No. EL/3.2.182

### **Modification Sheet No. ELRS/MS/0355 ( Rev.'2')**

Modification to support Winding overhang(double support at connection end and single support at non-connection end) and augmentation of insulation scheme of stators of Three phase traction motor type 6FRA 6068 during new manufacturing/re-winding. **This MS supersedes MS-0355 (Rev-1) & MS 0356 (Rev-1).**

RDSO.ELECT.DTE. SKEL-4848  
ALT '0'

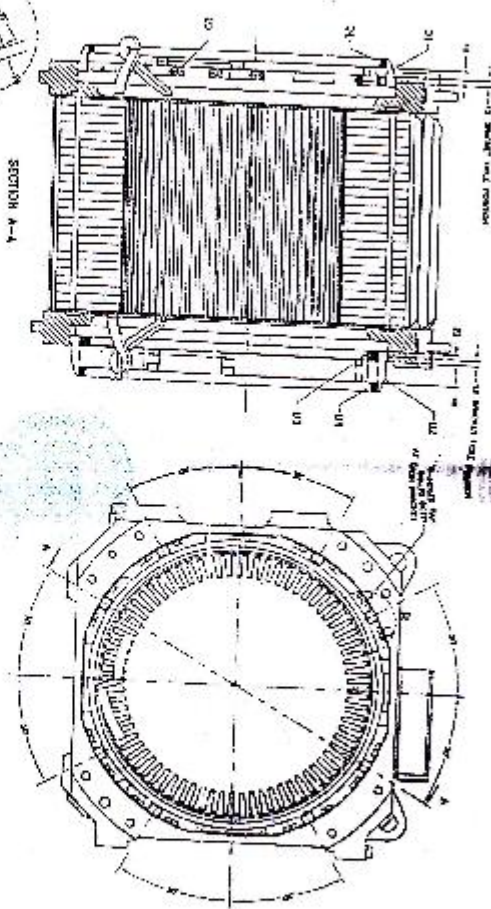
- 2.2 Fix 8 nos. of brackets on connection end of the stator chambers of and another 8 nos. on non connection end as per drawing no SKEL 4849 alt-1 at the locations as per drawing no SKEL 4848 Alt-1.

- 2.4 Finally the winding overhangs are to be tied with two bracing rings at connection end and with one bracing ring at non-connection ring as per arrangements shown in drawing no SKEL-4848 Alt-0.

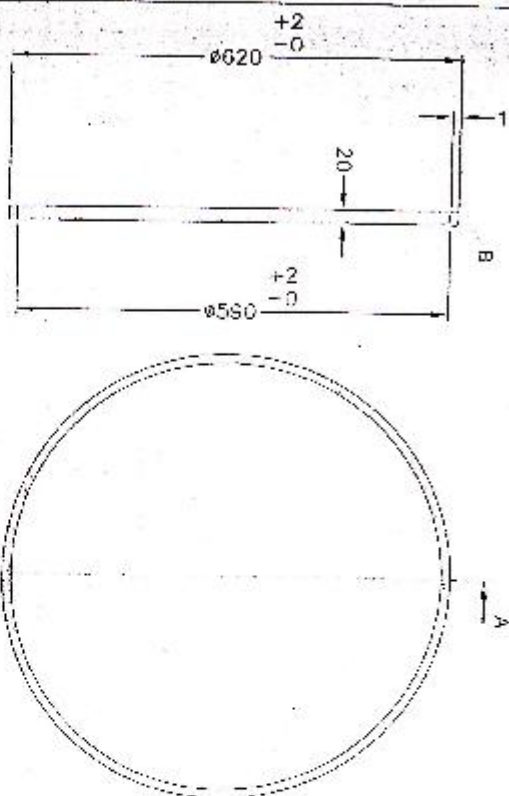
- 2.3 Two nos. of FRP bracing rings e.g. outer bracing ring (SKEL-4850) and inner bracing ring (drawing no SKEL-4851) are required to be tied on brackets bolted on connection end stator chambers. One FRP bracing ring (drawing no SKEL-4852) is required to be tied on brackets bolted on non-connection end stator chamber.
